Fuel Tank Band Bolt Dealer Inventory

Reference: P8337
Date: January 17, 2019

P8337 – ROGUE SPORT FUEL TANK BAND BOLTS

Figure 2

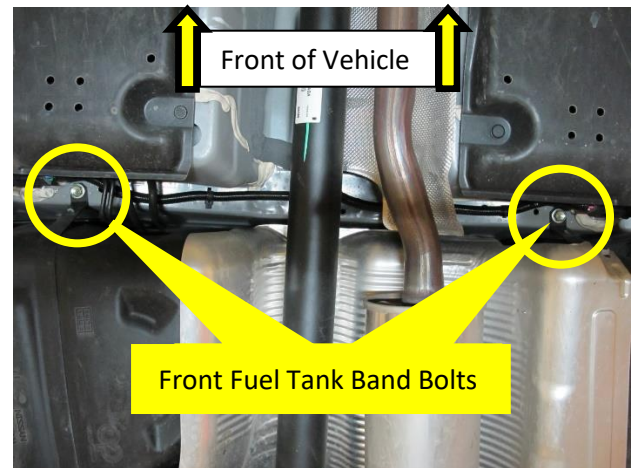
2. Locate the FRONT fuel tank band bolts.

Figure 3

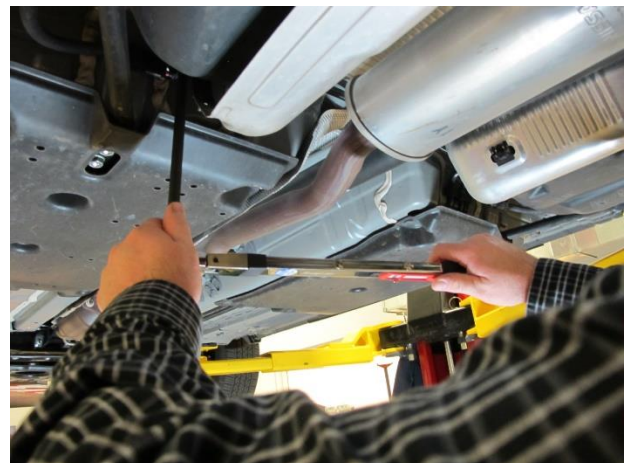
3. Torque the Front fuel tank band bolts.
 - Torque both FRONT fuel tank band bolts to 23 ft-lbs (31.4 Nm).

NOTE: A 16MM socket and a 10-inch extension will be required.
